Re: Old Northern Road Quarry DA 250-09-01 Mod 5 - Response to Submissions

Groundwater Assessment - Modification no.5

Technical Design Note

Subject: Access design review

Figure 4.9 from Austroads Part 4a with projected traffic flows at site access on Old Northern Road (370 2-way movements including site truck movements and 15 vehicles per hour entering and exiting the site)

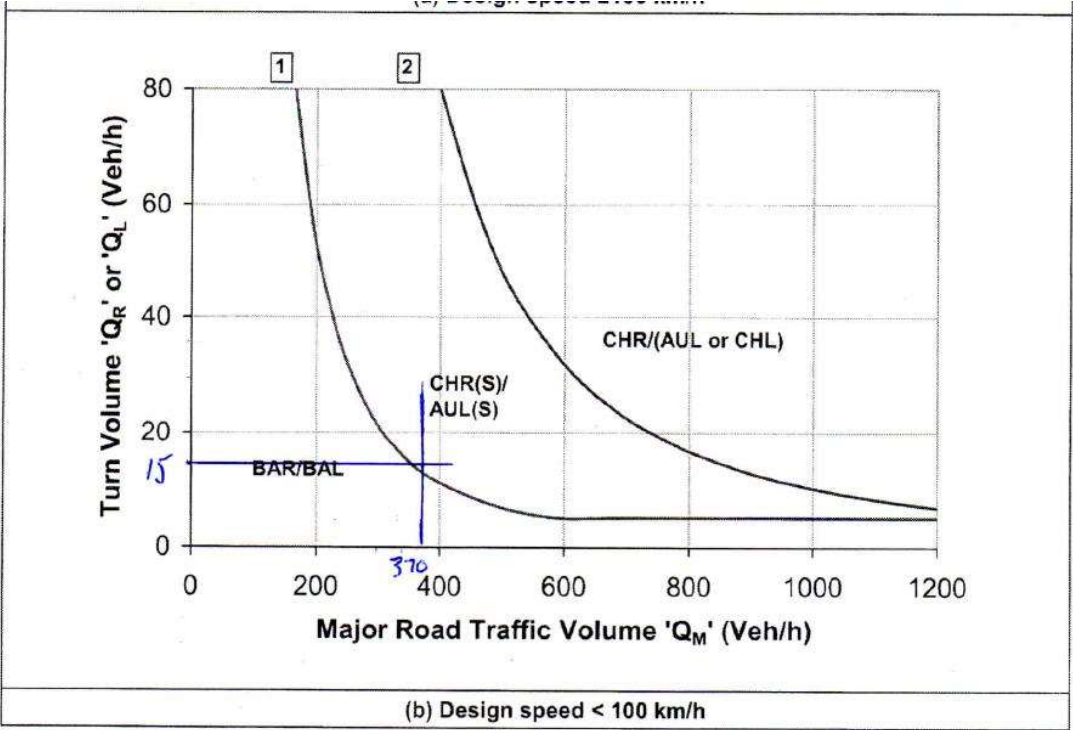
Further information is required showing that the access meets the required treatment as per AUSTROADS and the need for improvement (if required). The proponent should investigate the required access arrangement/intersection treatment in compliance with AUSTROADS Guide to Road Design Part 4A: Unsignalised and signalised intersections using the graph in Figure 4.9 which will give an indication of the type of right and left turn treatments required.

From our assessment work, the future two-way traffic flow along Old Northern Road for 2042 are projected to be in the order of 3,700 vehicles per day giving 370 vehicles during the morning and afternoon peak hours. Traffic flows for the quarry site will remain at 180 per day total, giving 90 inbound and 90 outbound per day as per the current consent. Allowing for 15 trucks entering and exiting the site in one hour, the intersection layout requirements have been assessed to warrant a type CHR (S) / AUL (S). Given there are no right turns for the site this shows that the intersection will require a short left turn deceleration lane only.

The current access arrangements for the site access on Old Northern Road provides a short left turn lane which is approximately 100 m long. Based on Table 5.2 of Austroads Part 4a the deceleration lane length required for the 80 km/h speed zone is 95 metres for an exit speed of 20 km/h. Therefore, the current left turn lane is adequate for the future design year of 2042.

Based on the above it can be seen that the current site access layout is in accordance with current standards and can continue to operate in a safe and acceptable manner up to the future project design year of 2042.
